Supplement to the Response to Comments on the  
Technical Drainage Study for

CSN Center For Excellence In Public Safety

<b>CITY OF LAS VEGAS INTER-OFFICE MEMORANDUM</b>		<b>DATE:</b> April 22, 2025
<b>TO:</b> Land Development Services Department of Community Development – Building & Safety Division		<b>FROM:</b> Tyler Key Flood Control Engr. Associate Department of Public Works
<b>SUBJECT:</b> Drainage Study for: <b>CSN Center For Excellence in Public Safety</b>		<b>COPIES TO:</b> GCW, Inc.
<b>Cross Streets:</b>	Durango Dr. & Elkhorn Rd.	Nevada System of Higher Education
<b>File Number:</b>	F:\Depot\DSMemos\DS5826B.doc	Lucien Paet P.E., DevCo
<b>Parcel Number:</b>	125-17-801-009	
<b>Zoning Action:</b>	24-0545-[VAR1, SDR1]	
<b>FEMA Flood Zone</b>	YES NO <b>X</b>	
<b>Proposed Storm Drain</b>	YES <b>X</b> NO

**Subject: Supplement to the Response to Comments on the Technical Drainage Study for CSN Center for Excellence in Public Safety (DS5826)**

## Cross Section for Elkhorn Rd (MAX SLOPE) (PRO 100YR) LS Riprap Sizing

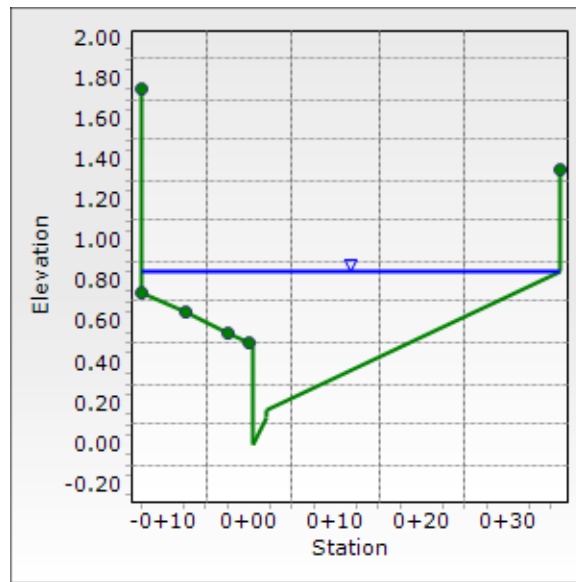
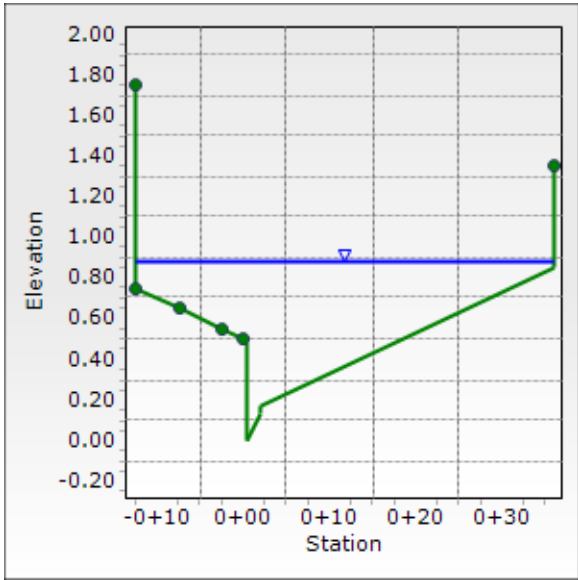
The FlowMaster cross sections can be extended from the median to the proposed wall along Elkhorn & Durango, but the section cannot be split into two sections with different flows. Flood protection is required along Durango & Elkhorn.

Acknowledged. Riprap has been provided a minimum of 6-inches above top of curb in the landscape portions along Durango and Elkhorn to provide protection from erosive velocities. Hydraulic sections to size the riprap have been provided in the Appendix. Note that since these sections include areas outside of the right-of-way they do not replace previous Sections 5A and 6A; however, the roadway still meets 100-year criteria, and the proposed finished floor is still flood protected using the results.

MAX SLOPE USED TO SIZE RIPRAP. DEPTH FROM MIN SLOPE CALCULATION USED TO CHECK HOW HIGH RIPRAP NEEDS TO EXTEND
